April 27, 2006

**RE: Addendum to Work Plan for Additional Site Characterization
and Report of Well Survey
SLIC Case RO0002567, Chung Property, 2942 San Pablo Avenue
Oakland, CA**

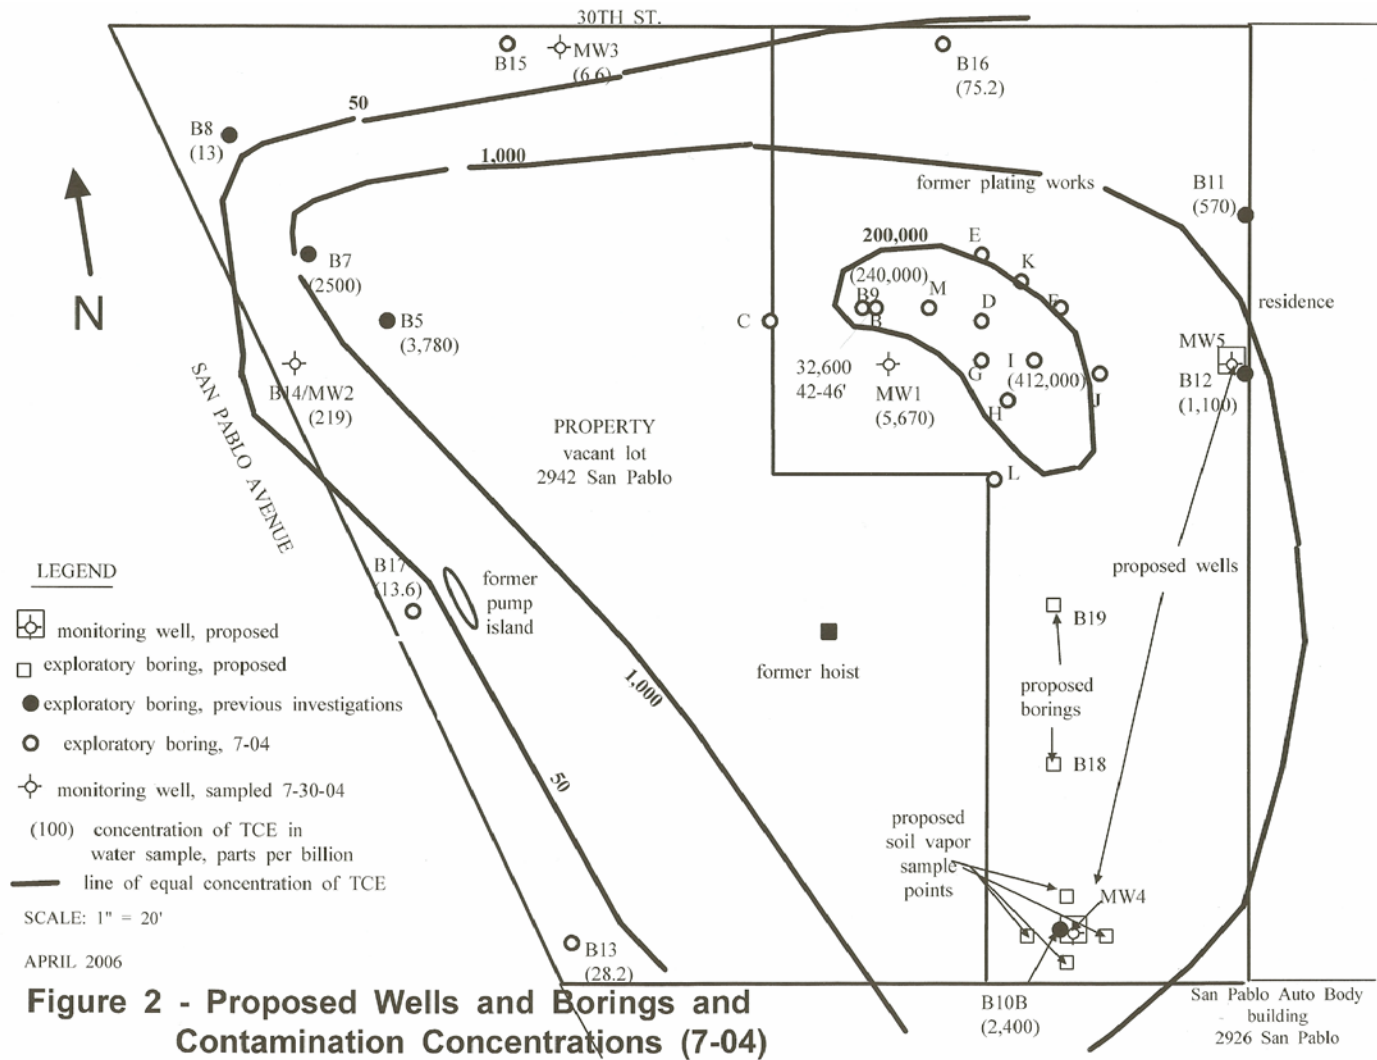
Potential Source Area near Boring B10B. The Work Plan proposes two soil borings located approximately 25 and 50 feet, respectively from previous boring B10B and one groundwater monitoring well adjacent to boring B10B to further delineate groundwater conditions and determine whether boring B10B represents a separate source. The proposed scope of work is not sufficient to assess whether a separate source exists in this area of the site. The Work Plan seems to argue that the soil results in boring B10B did not indicate a contaminant source in soil but also argues that the detection of 2,400 ppb of trichloroethene (TCE) in groundwater is not representative of groundwater flow conditions. These arguments seem to indicate that the TCE detected in boring B10B got there with no local source or a groundwater migration pathway. We request that you submit plans to collect soil vapor samples in the area of boring B10B to evaluate whether a local source of VOCs exists in this area.

With regards to your Technical Comment No. 2, four soil vapor borings are proposed in the vicinity of previous boring B10B. The locations of the borings are shown on the attached Figure 2.

The soil vapor samples will be collected using a Geoprobe direct push rig. An expendable drive point will be advanced ahead of the drilling rods at each location to an approximate depth of five feet below grade. A Teflon tubing sampling line will be installed into the drilling rods. The tubing will be fitted with a threaded fitting that will attach to a “point holder” with an O-ring to create a seal. The sampling line will be capped with a vapor-tight valve. The drilling rods will then be raised six inches to create a void. Sampling will take place after a 30-minute interval to allow conditions to equilibrate.

Figure 4 - Proposed Surficial Sample Points - Metals

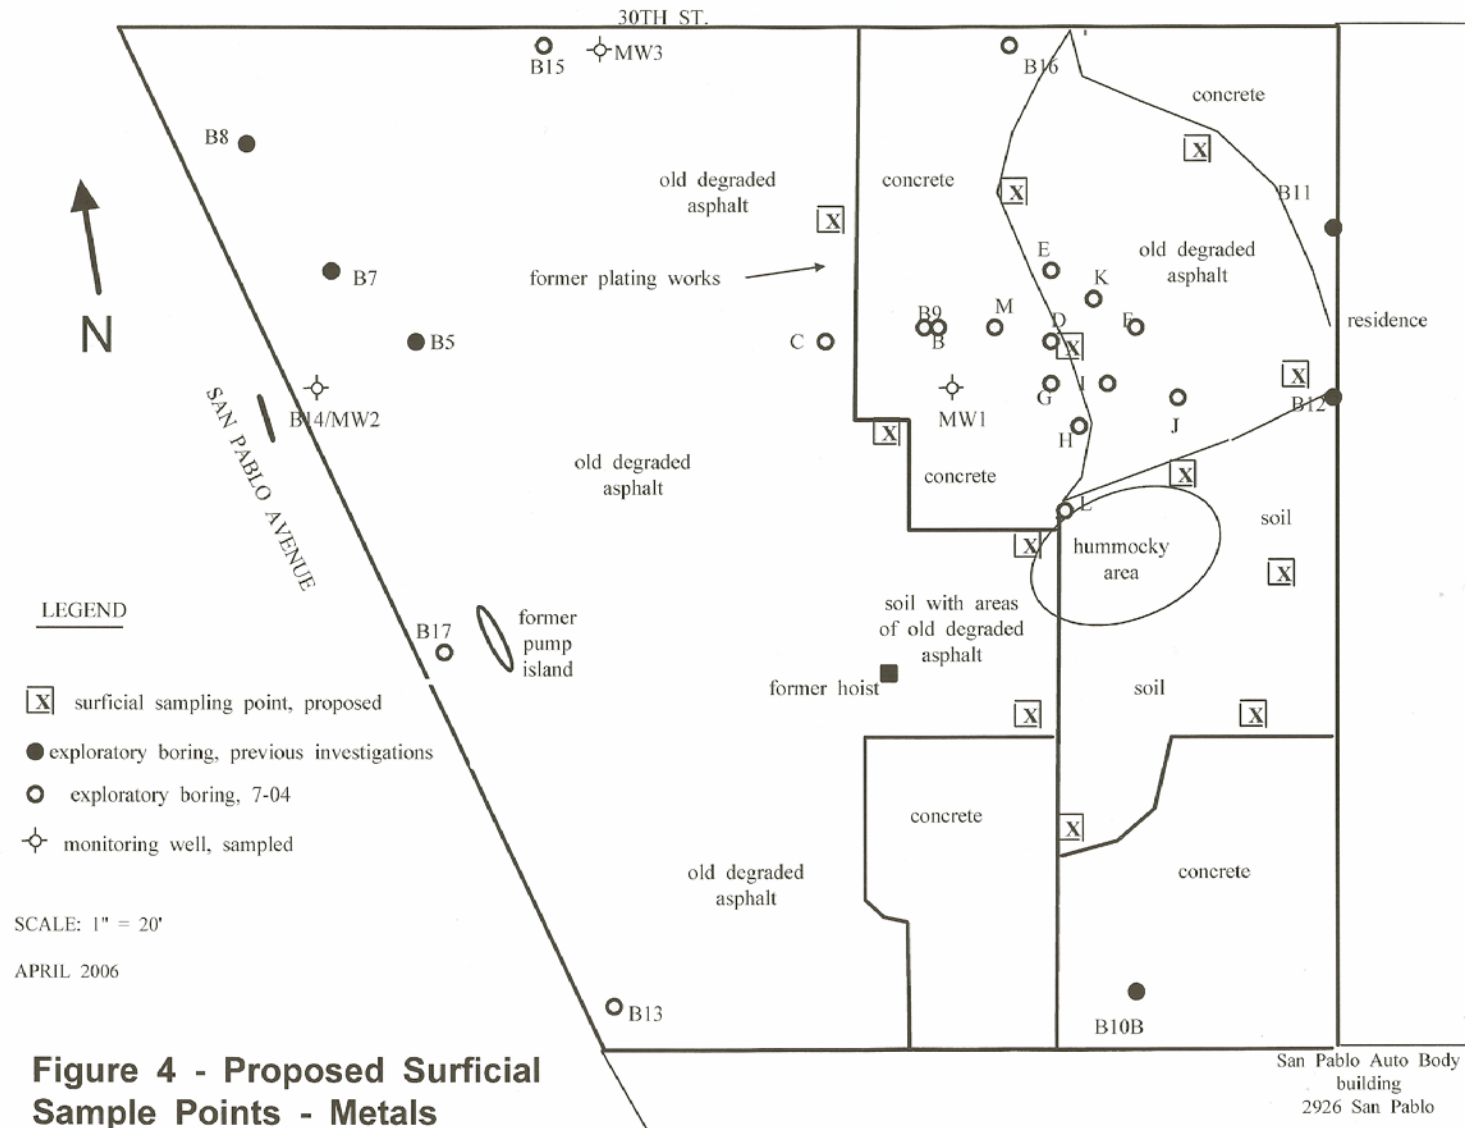
Metals and Cyanide. The proposal to collect composite soil samples to characterize the extent of metals and cyanide at the site may be acceptable. However, in order to evaluate whether the proposed soil sampling will adequately characterize the extent of metals and cyanide, we request that you submit a map showing the planned soil sampling locations, the areas covered by concrete, and any features within the concrete that could be conduits to the soil. Please submit the map in the Work Plan Addendum or revised Work Plan requested below.

In response to your Technical Comment No. 5, a map showing the location of the concrete at the former plating works, and the proposed twelve surficial sampling points, is included as the attached Figure 4. No specific targets that would represent conduits to the subsurface were identified during a recent reconnaissance to map the areas of concrete, soil, and degraded asphalt.
